NOTICE OF APPROVAL

Planning Case #: Design Study 20092

Re: Focused Historic Assessment, Scenic Drive, NE Corner of 8th Ave., Carmel, CA
APN 010-311-014; DS 20-092 (JMG Partners)

BEACH HOUSE REMODEL
N.E. CORNER OF SCENIC & 8TH AVE.
CARMEL-BY-THE-SEA
CA 93923

4 PROPOSED NORTH COURTYARD
SCALE: 1/4"=1'-0"

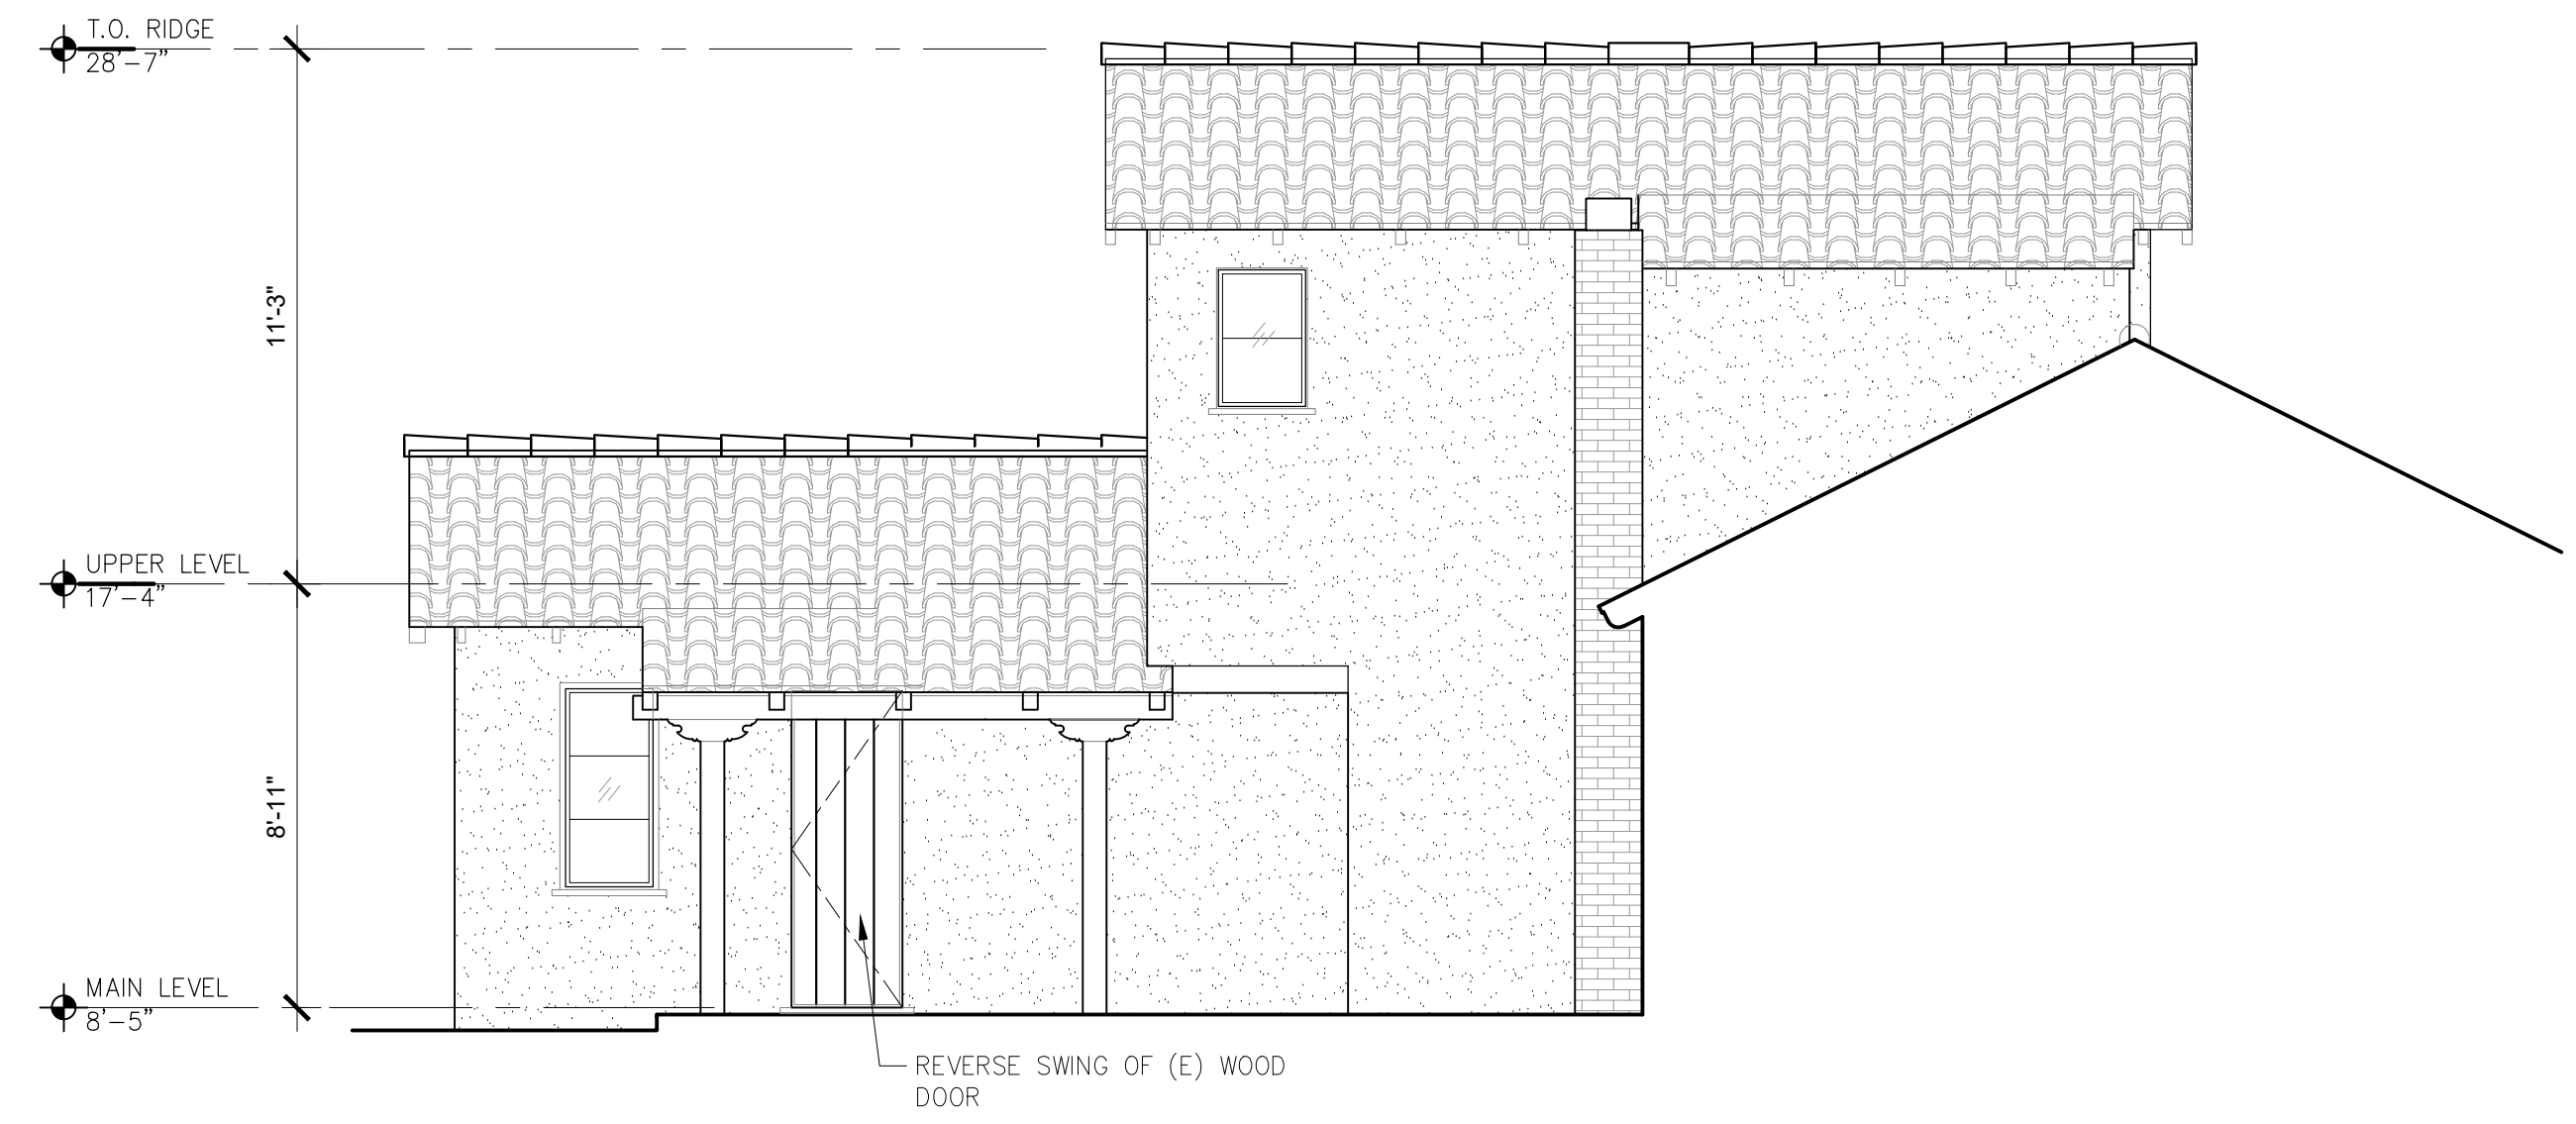
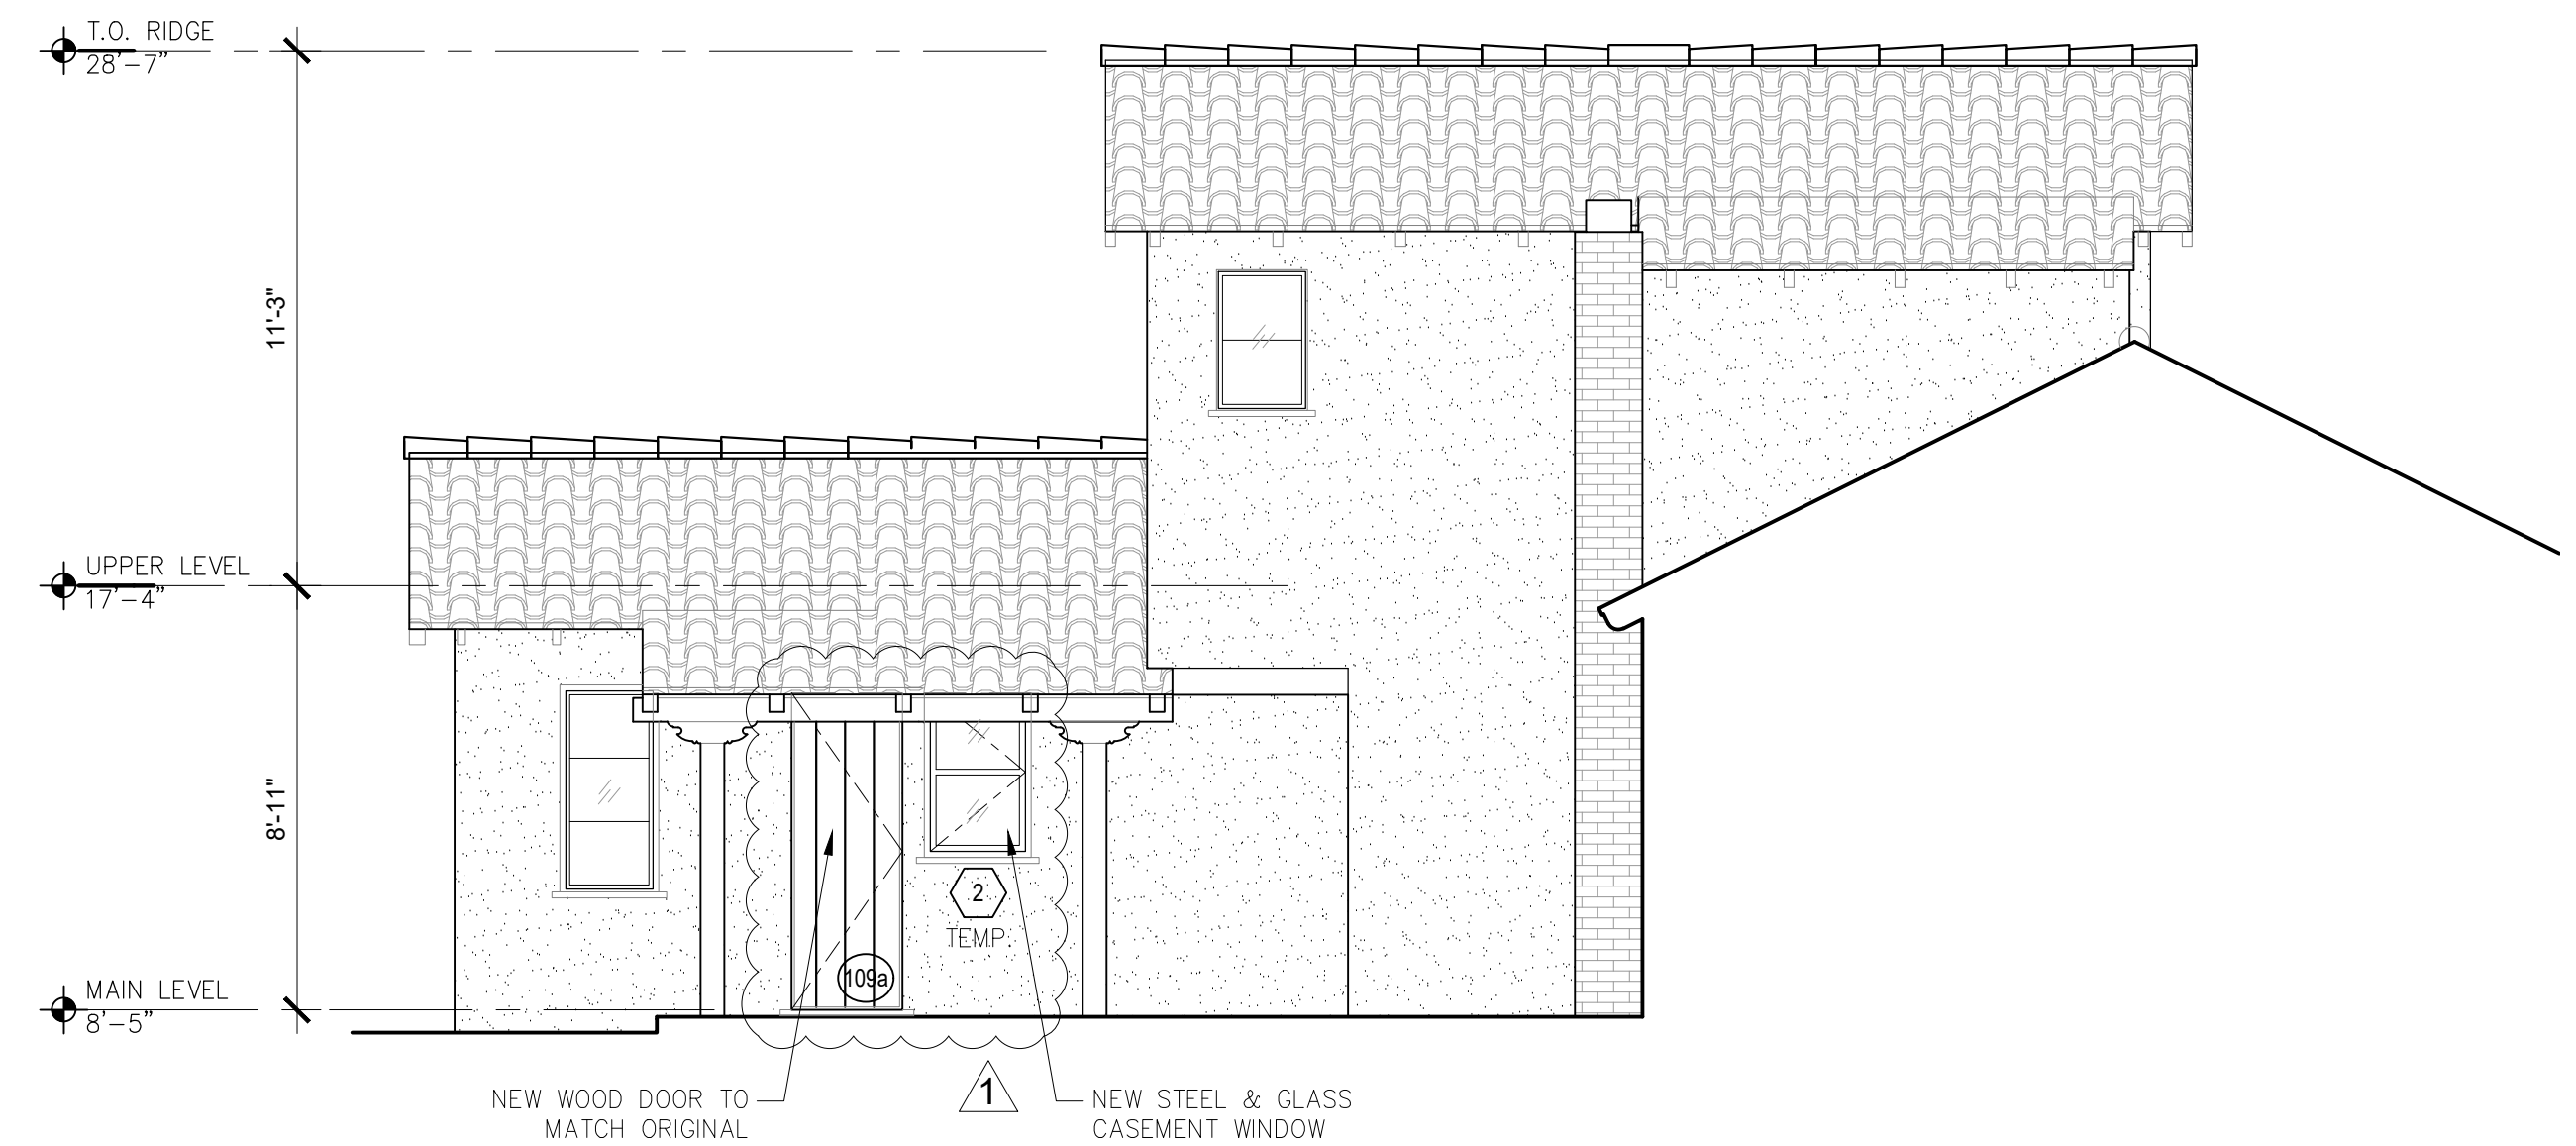
The proposed rear elevation's enlarged openings for French doors are appropriate according to the *Standards* because they are on the rear and non-primary elevation.

The proposed openings to the rear elevation are larger than proposed previously. However, their location on the rear and non-primary elevation is in keeping with this *Standard*.
